**ADDENDUM NO. 2**

DATE: January 31, 2024

PROJECT: Benton Washington Regional Public Water Authority
Phase 1A – Water Treatment Plant Improvements – High Service Pump Station
Rogers, ArkansasBID DATE: February 21, 2024 at 2:00PM

JOB NO:
2124
SHEET NO:
B5

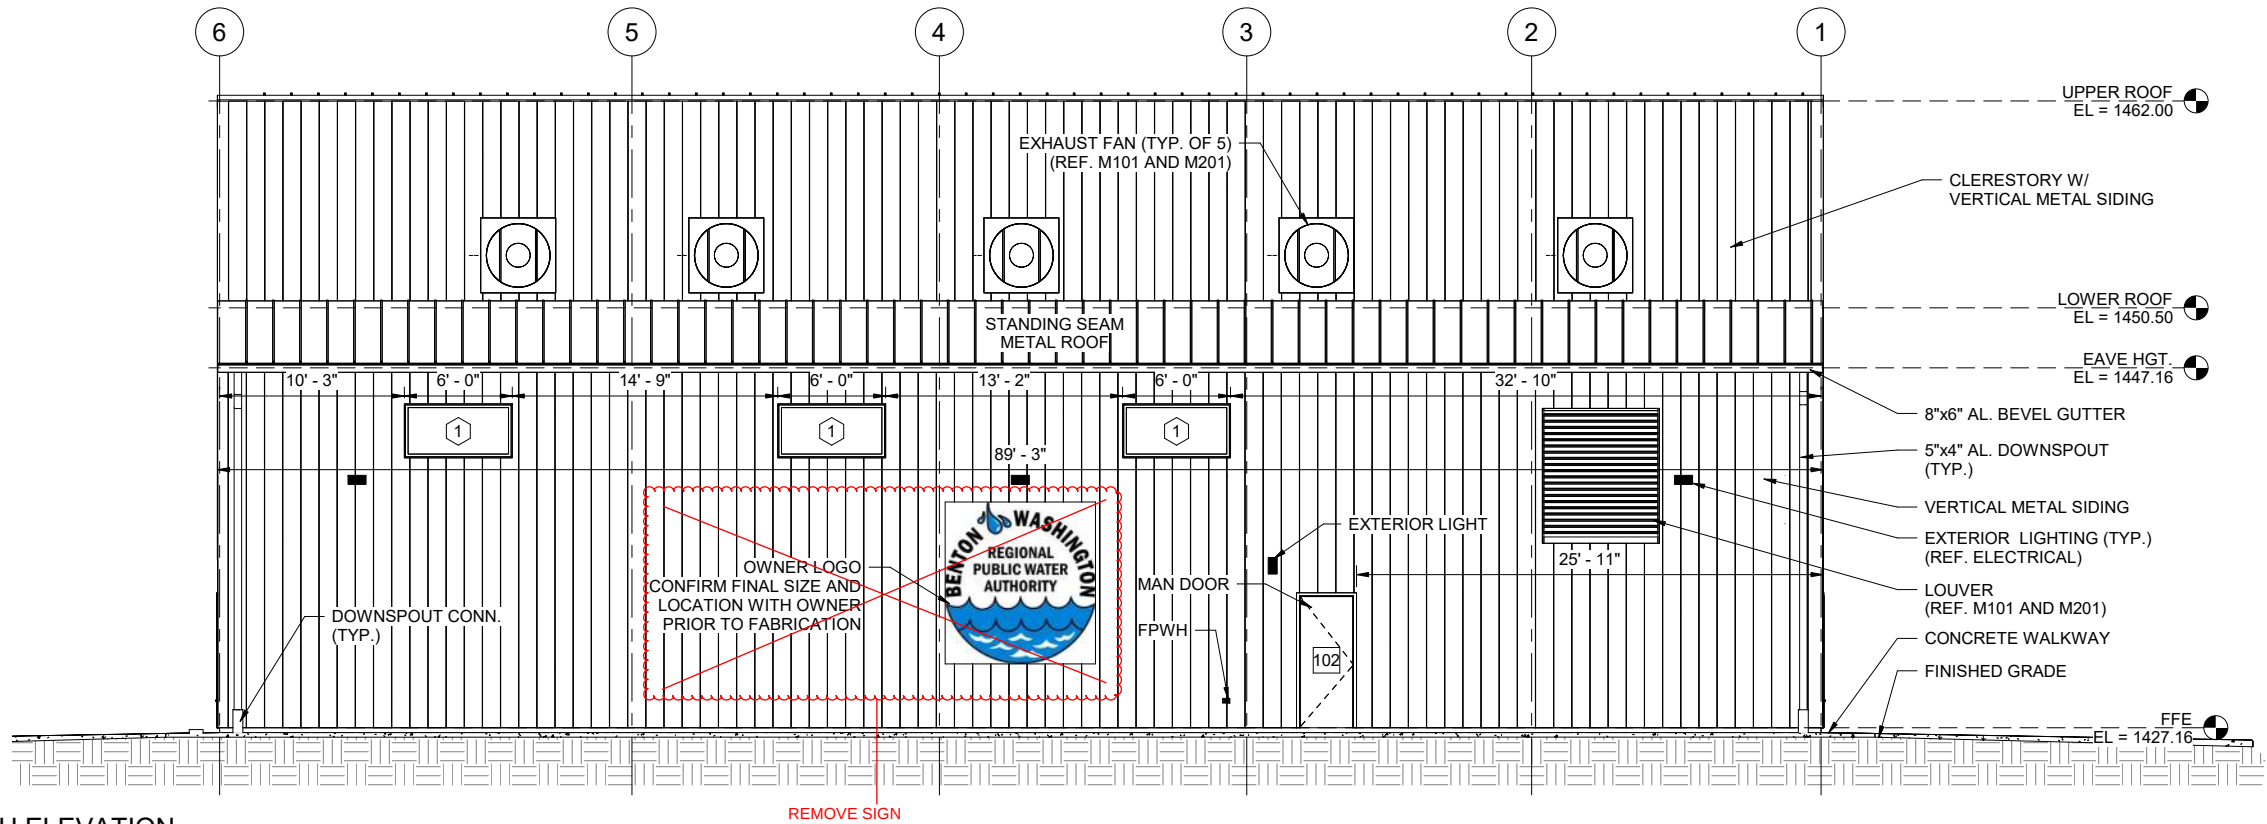
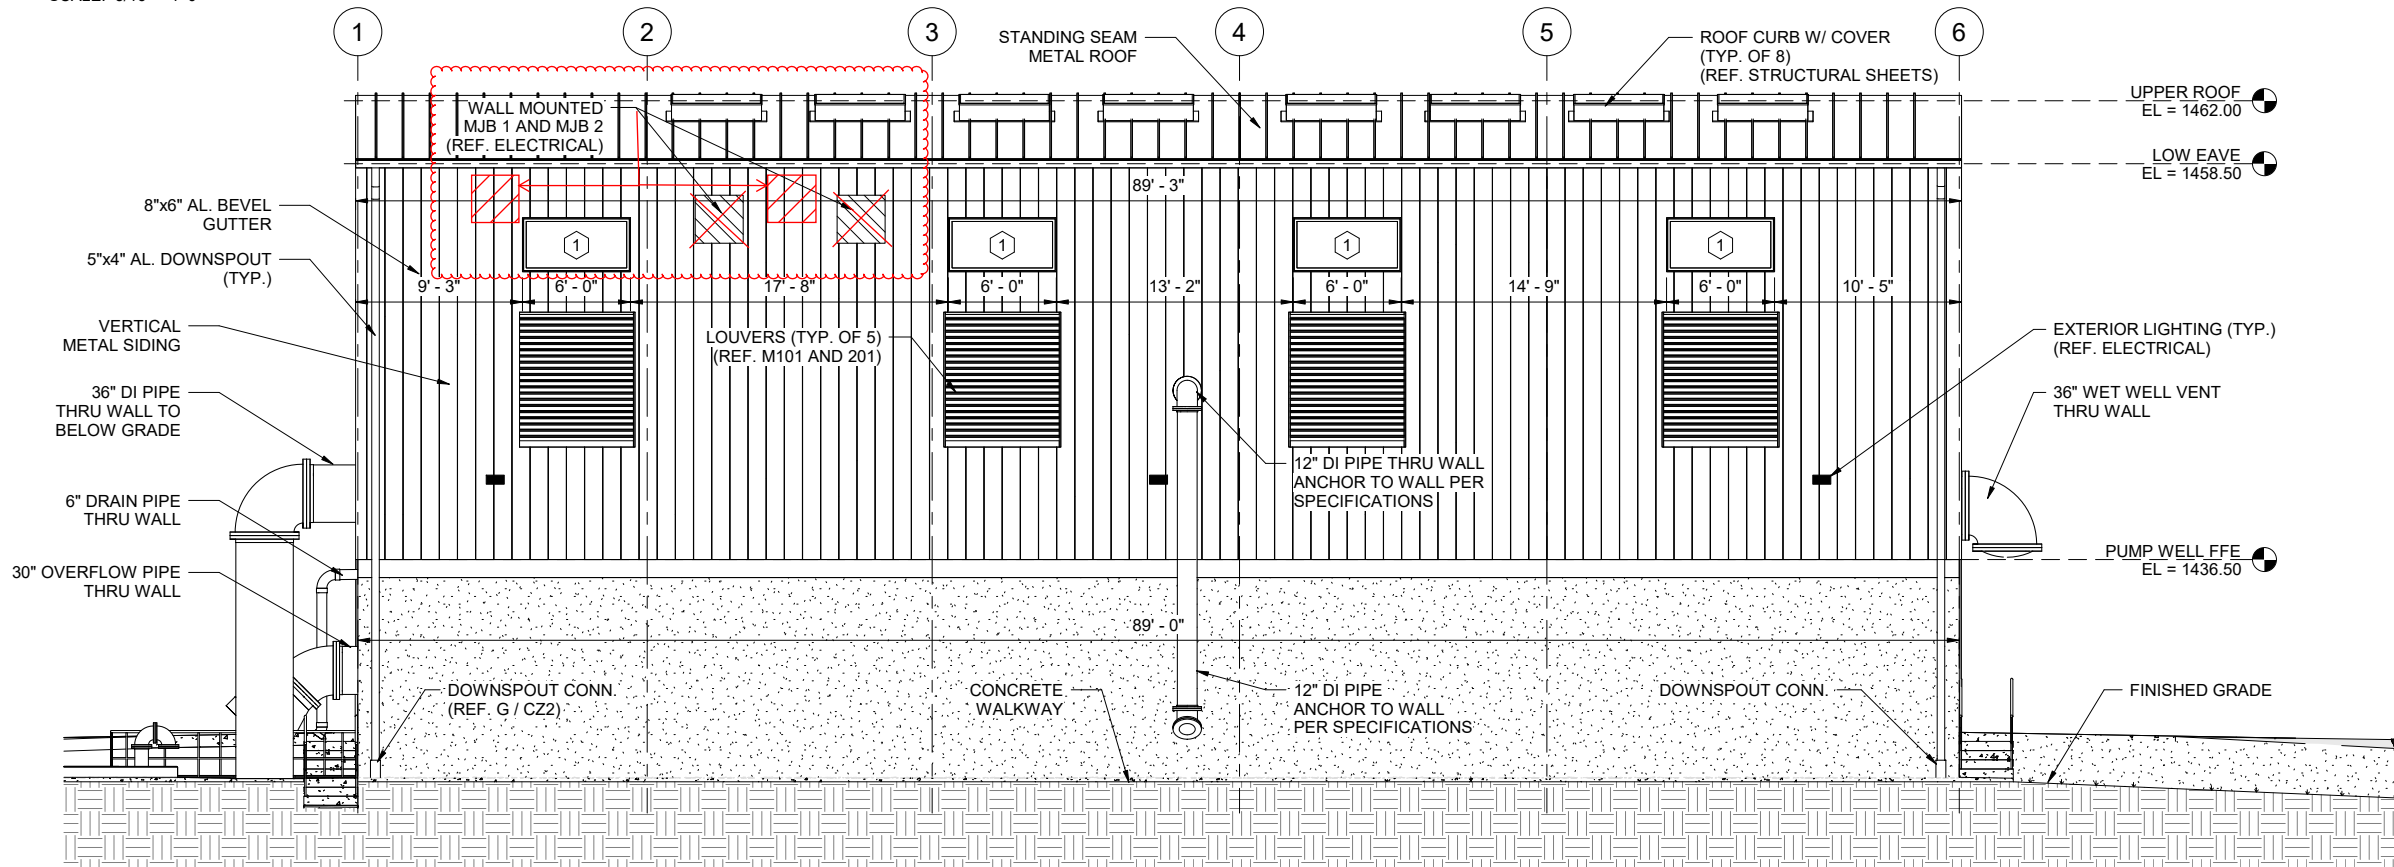
REV. NO.	DATE	DRWN	CHKD	REMARKS
1	1-31-24	CEI	JDM	ADDENDUM NO. 2, MODIFIED ELECTRICAL EQUIPMENT LOCATIONS AND REMOVED SIGN

JOB NO.	2124
SHEET NO.	S13

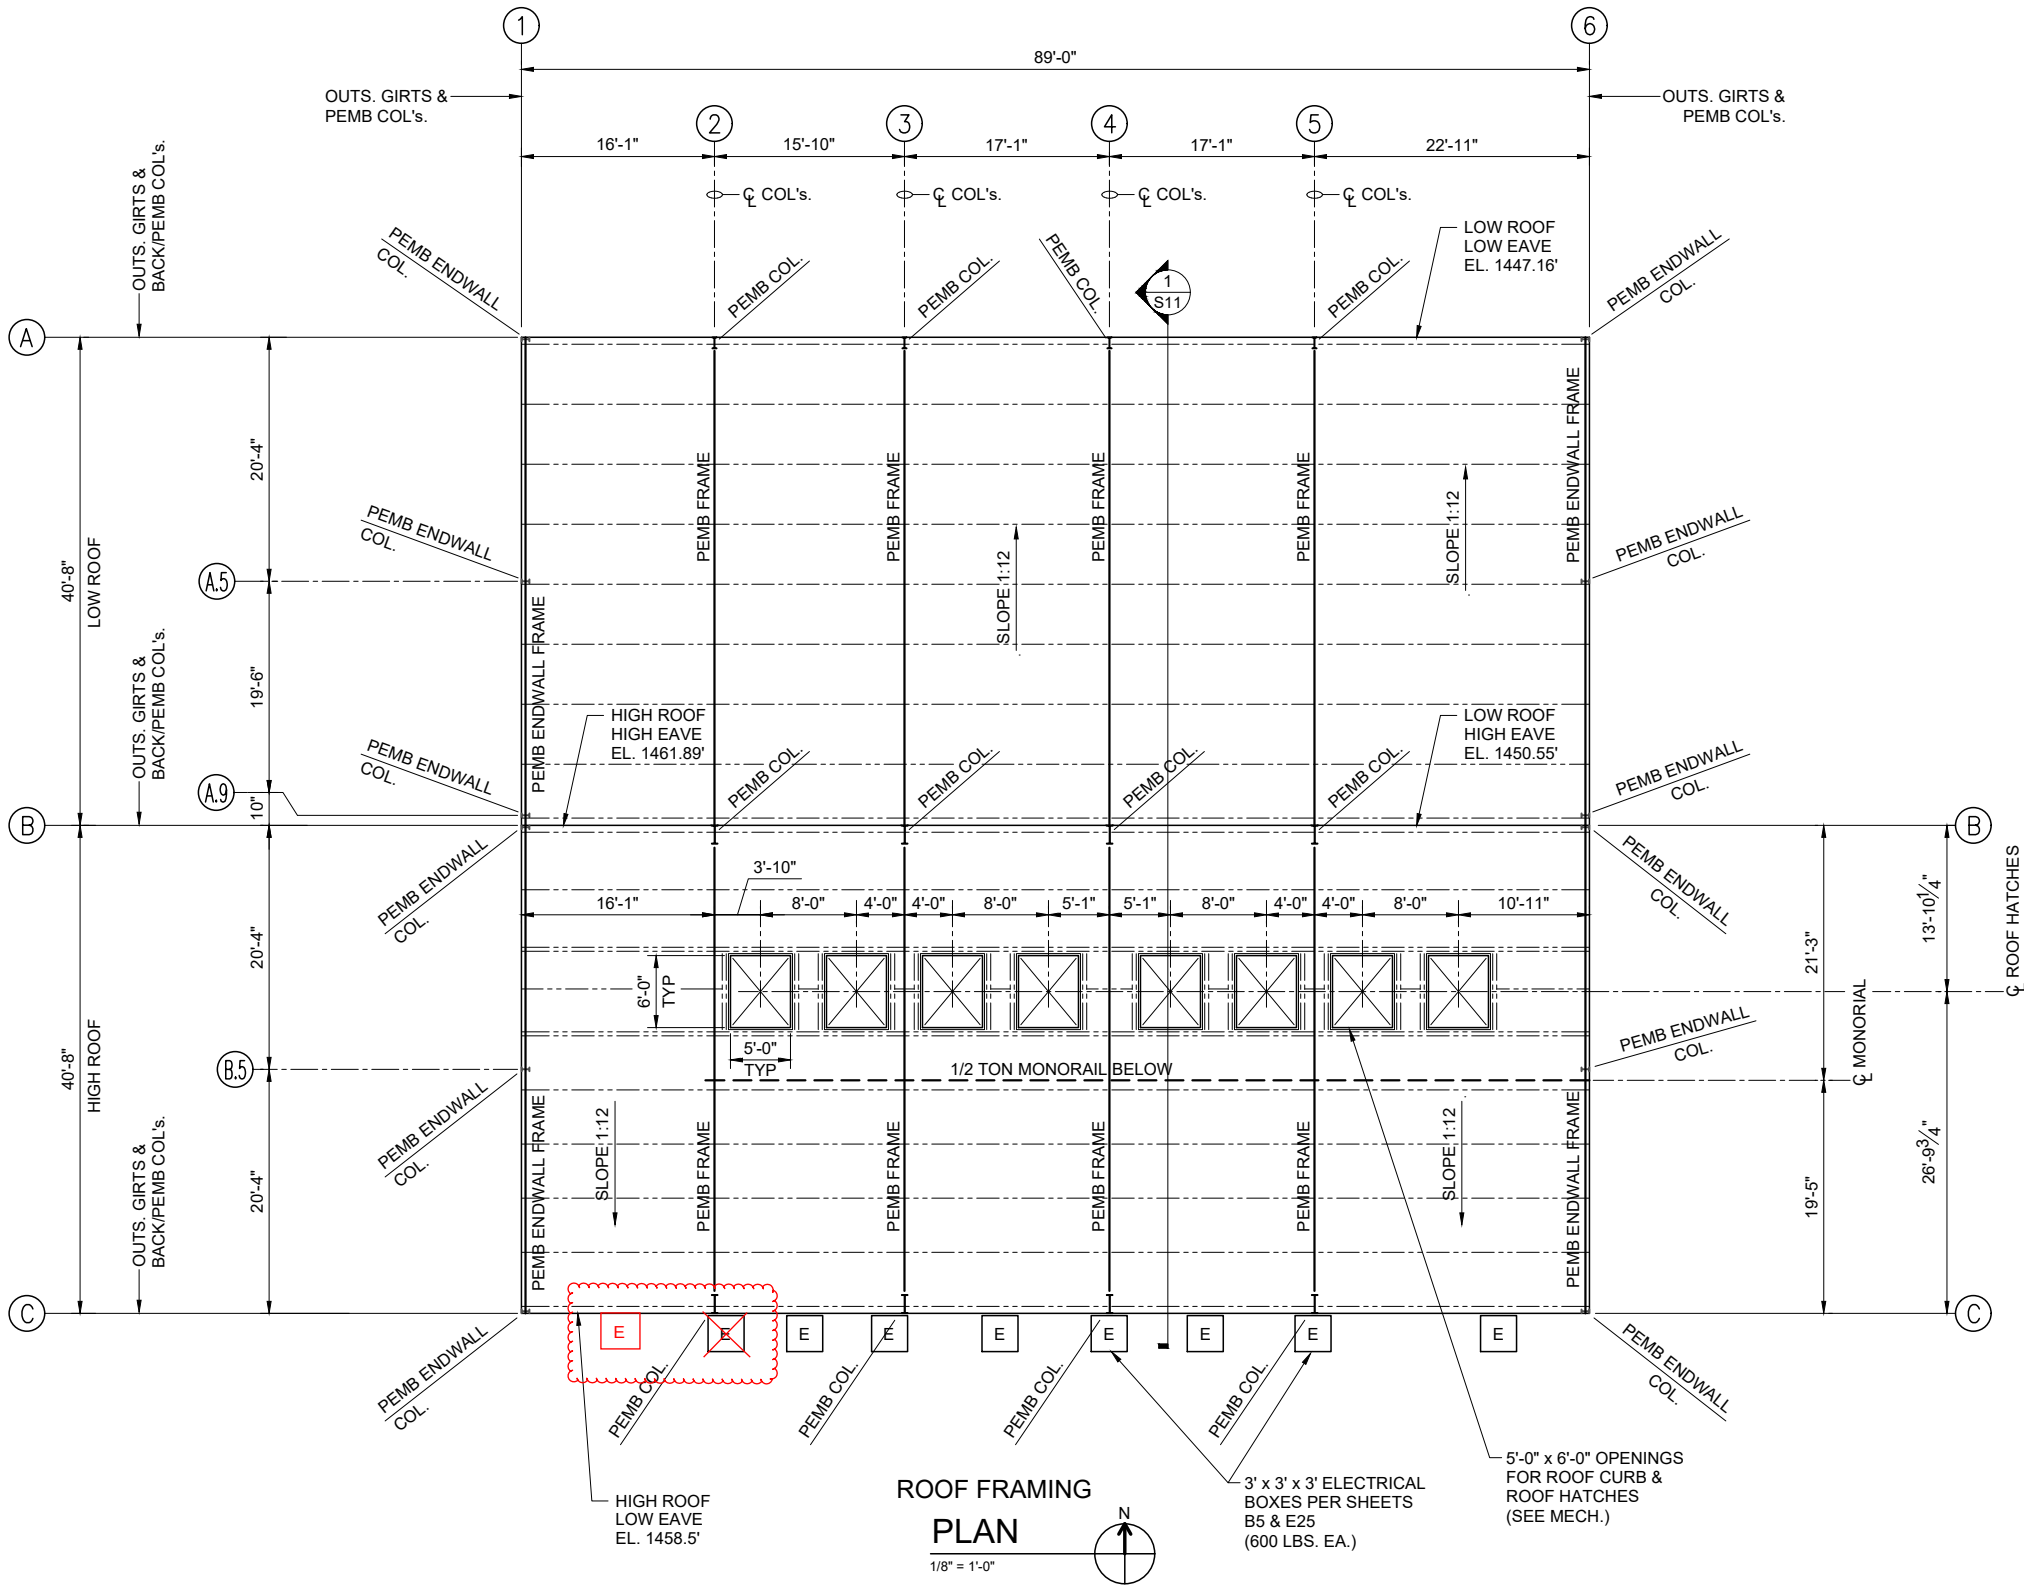
REV. NO.	DATE	DRWN	CHKD	REMARKS
1	1-31-24	CEI	JDM	ADDENDUM NO. 2, MODIFIED ELECTRICAL EQUIPMENT LOCATIONS

JOB NO:
2124
SHEET NO:
MP1

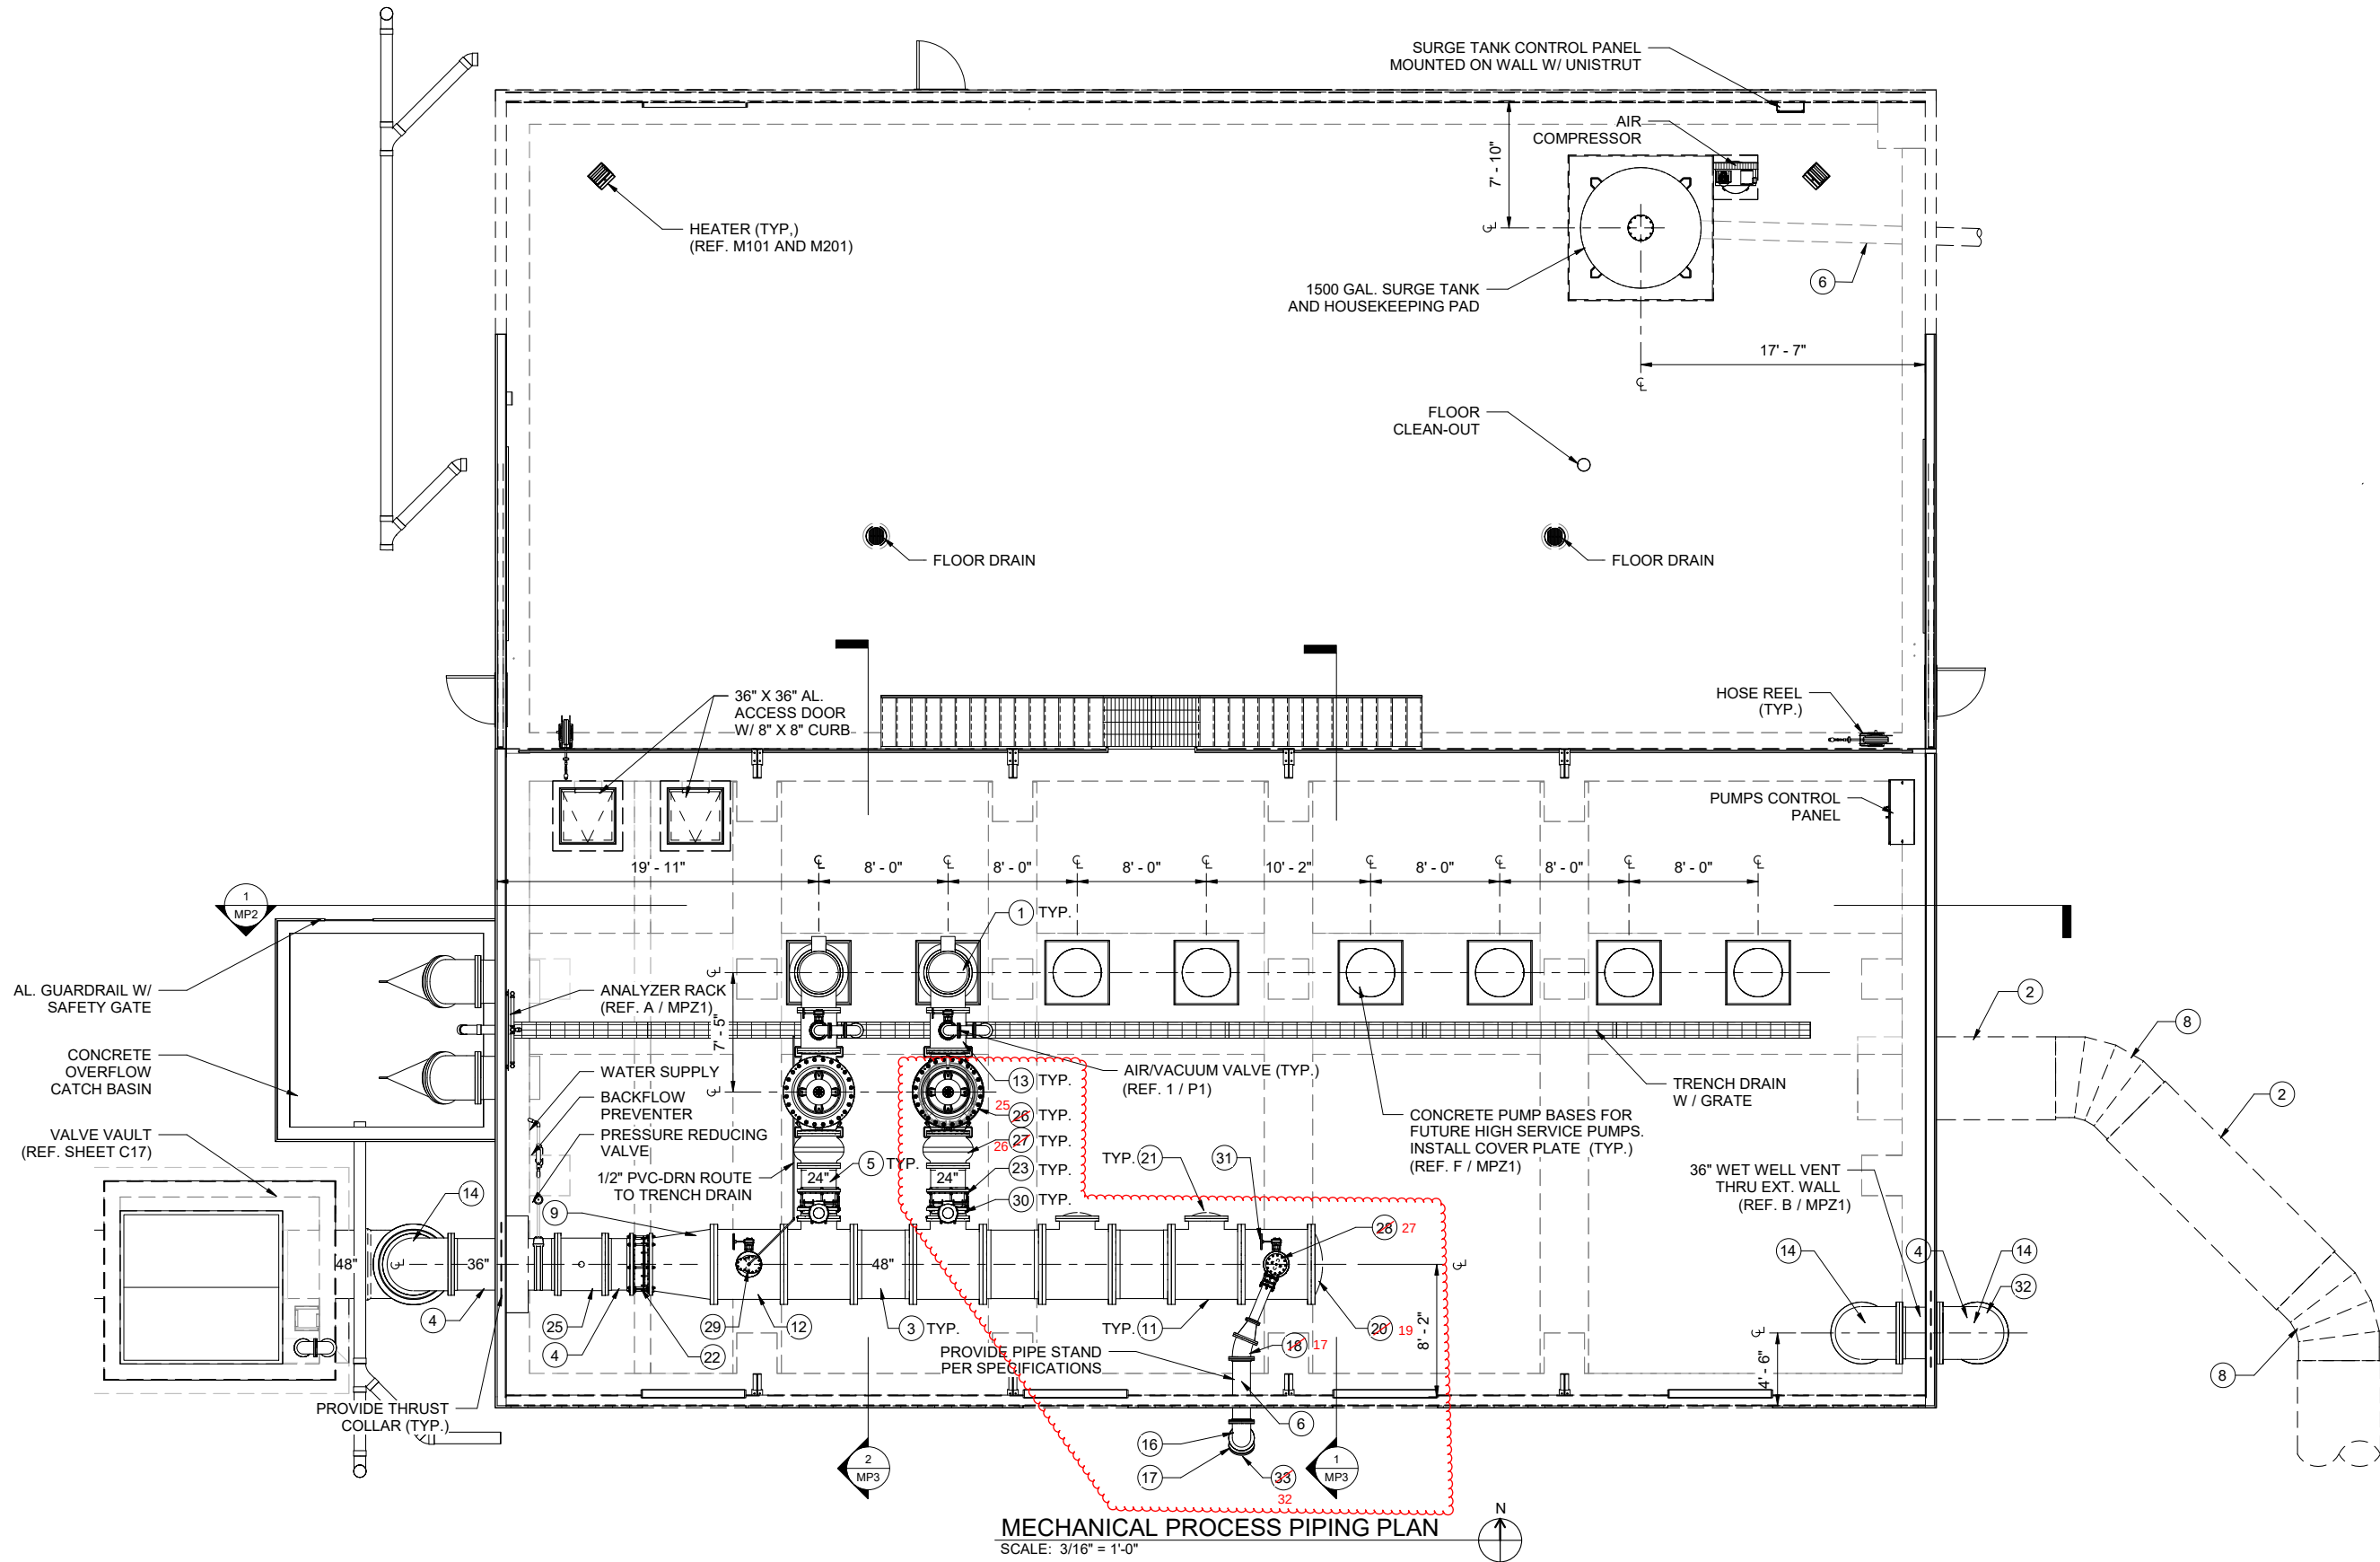
REV. NO.	DATE	DRWN	CHKD	REMARKS
1	1-31-24	CEI	JDM	ADDENDUM NO. 2, REVISED SCHEDULED EQUIPMENT MARKS
